# ADA Curb Ramp New Construction Inspection Form (Perpendicular)

Nw 289

24952.54

Nw union

## PERPENDICULAR RAMP (PR)

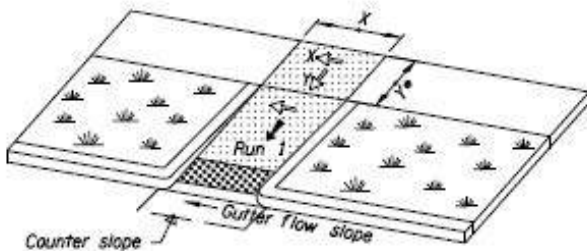
IITD RR1 fail
